PCN # ESW490-44 – Thyristor & Diode TO247_ISO247_PLUS247_ISOPLUS247 Packaging Location Transfer

Product/Process Change Notice (PCN)

PCN#: ESW490-44 **Date:** June 28th, 2022

Thyristor & Diode
TO247_ISO247_PLUS247_ISOPLUS247
Package Products

SBU - LIPA TUBE LABEL

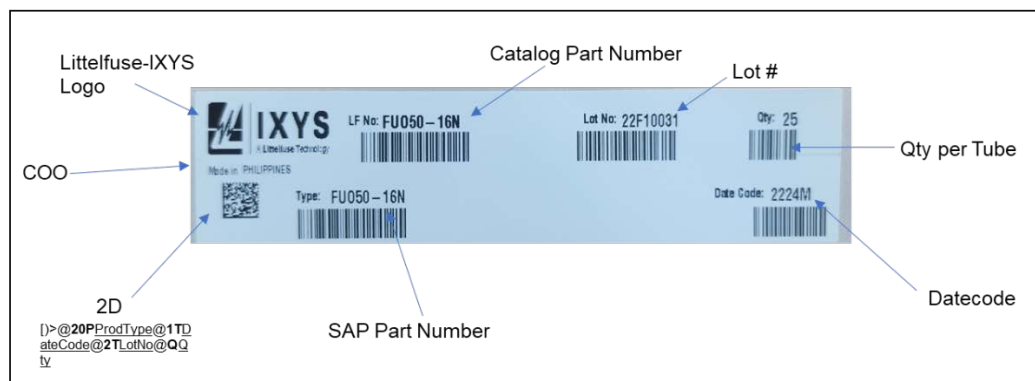
DESCRIPTION	EXISTING LOCATION	SBU-LIPA	CHANGE (Y/N)	RISK	REMARKS
Unit Marking					
Logo			Y	LOW	Change to Littelfuse Logo
UL Sign	Yes	Yes	N	NR	No change
Trademark Sign	Yes	Yes	N	NR	No change
Product Name	Yes	Yes	N	NR	No change
Date Code	YYWW	YYWW	N	NR	No change
Assembly Line Code	L	M	Y	LOW	Site location code
Lot ID	FKT #	Lipa Lot ID format	Y	NR	SBU-Lipa uses global format
Box Label					
RoHS Label	e1 	e3 	Y	LOW	Both have printed RoHS compliance label
Logo			Y	NR	Change to Littelfuse Logo
Qty per Box	Yes	Yes	N	NR	No change
Part Number	Yes	Yes	N	NR	No change
Lot No	No	Yes	Y	LOW	Additional information from SBU-Lipa
Country of Origin	Yes	Yes	N	NR	No change
Code Type	Barcode	Barcode + 2D Code	Y	LOW	Additional scanning code to access information
Lot ID	FKT #	Lipa Lot ID format	Y	NR	SBU-Lipa uses global format
Date Code	Yes	Yes	N	NR	No change
Assy Line Code	L	M	Y	LOW	Site location code
Tube Label					
Logo			Y	NR	Change to Littelfuse Logo

Qty per tube	Yes	Yes	N	NR	No change
Part Number	Yes	Yes	N	NR	No change
Lot No	No	Yes	Y	LOW	Additional information from SBU-Lipa
Country of Origin	Yes	Yes	N	NR	No change
Code Type	Barcode	Barcode + 2D Code	Y	LOW	Additional scanning code to access information
Lot ID	FKT #	Lipa Lot ID format	Y	NR	SBU-Lipa uses global format
Date Code	Yes	Yes	N	NR	No change
Assy Line Code	L	M	Y	LOW	Site location code
